GAINES CHARTER TOWNSHIP
PLANNING COMMISSION – REGULAR MEETING
Township Board Room - 8555 Kalamazoo Ave. S.E. Caledonia, MI 49316

DRAFT Agenda

Planning Commission Memo

Re: DGX2 Plan Review

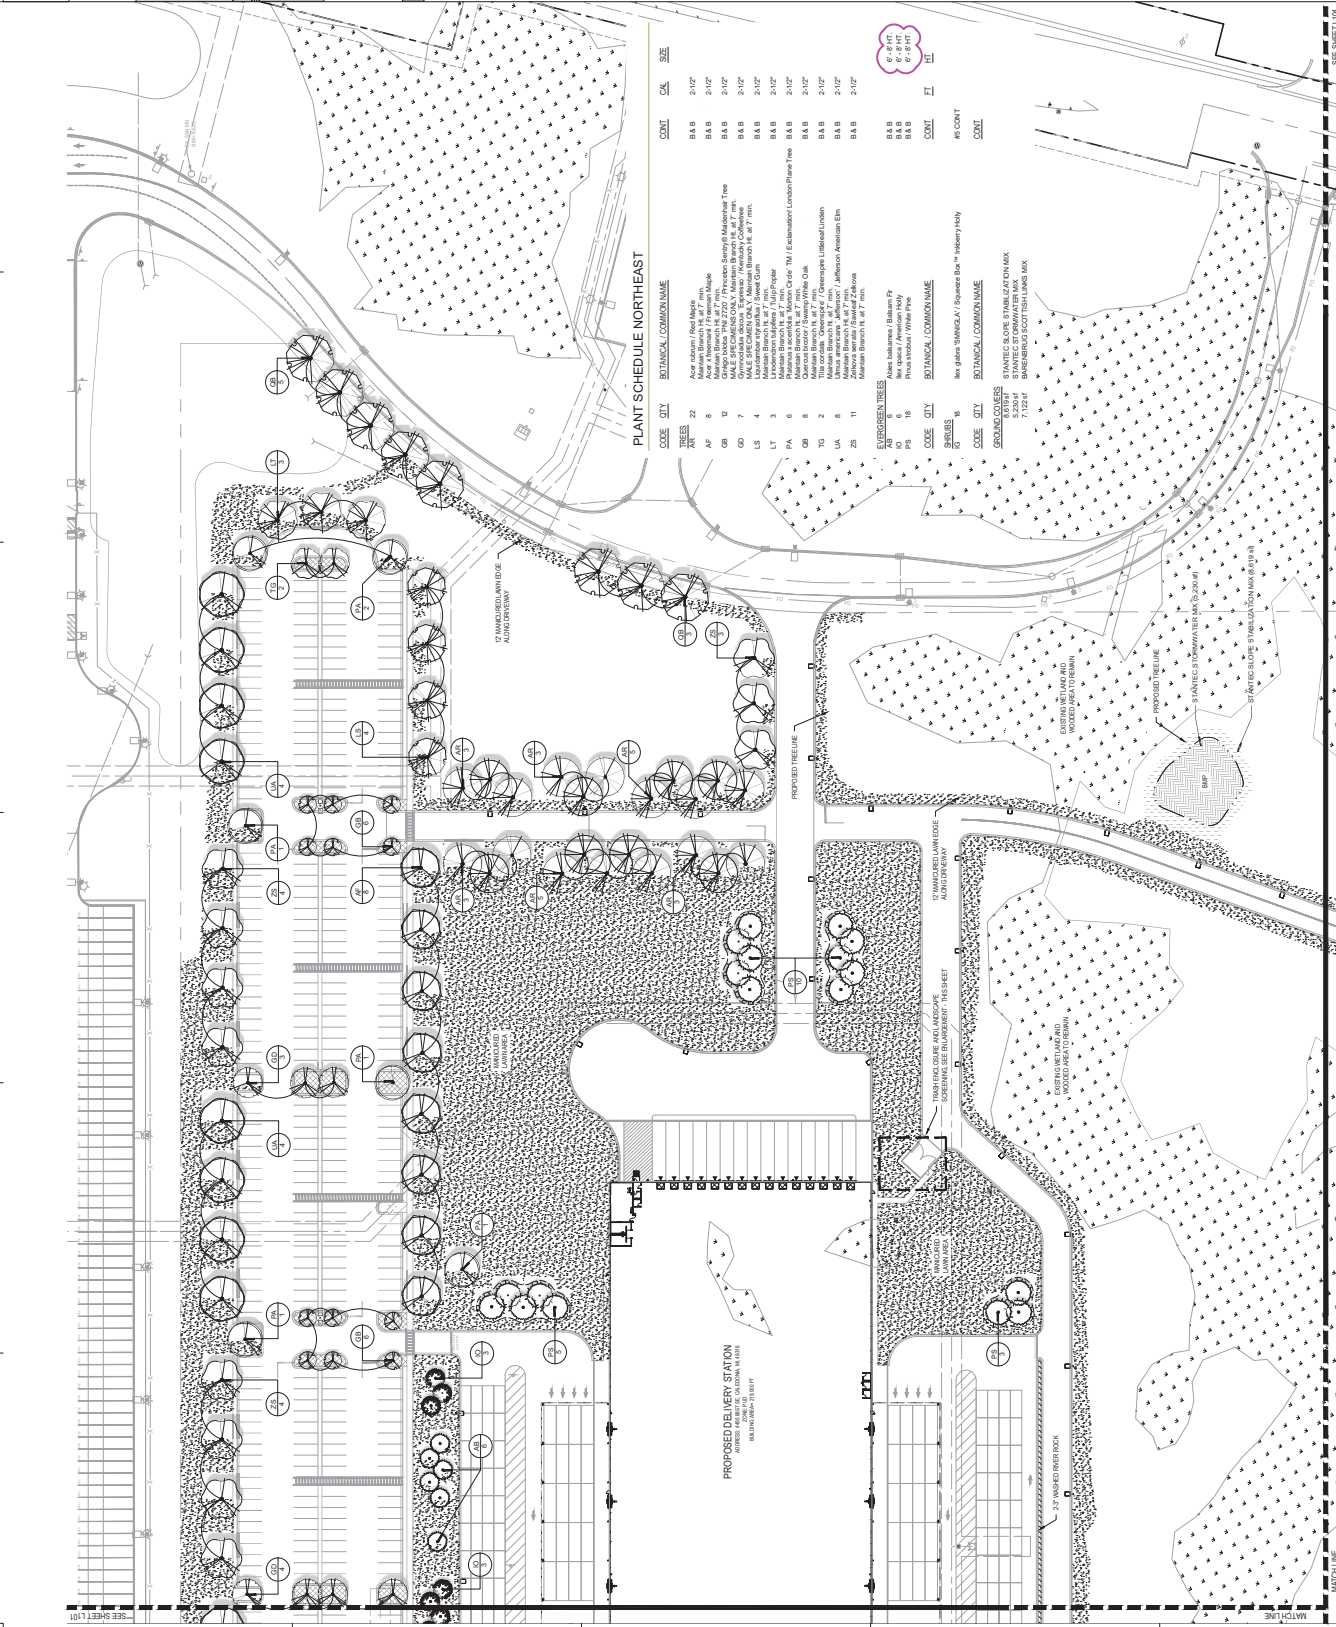
7. With regard to installation sizes for landscaping, 23.30.E.7 stipulates that evergreen trees must be installed at a size of no less than 6 feet; I see on the site plans that balsam firs are noted as being 5 feet upon installation.

Progressive Companies Response: All evergreen trees are to be 6-8 feet tall at installation. The plant schedules have been adjusted accordingly.
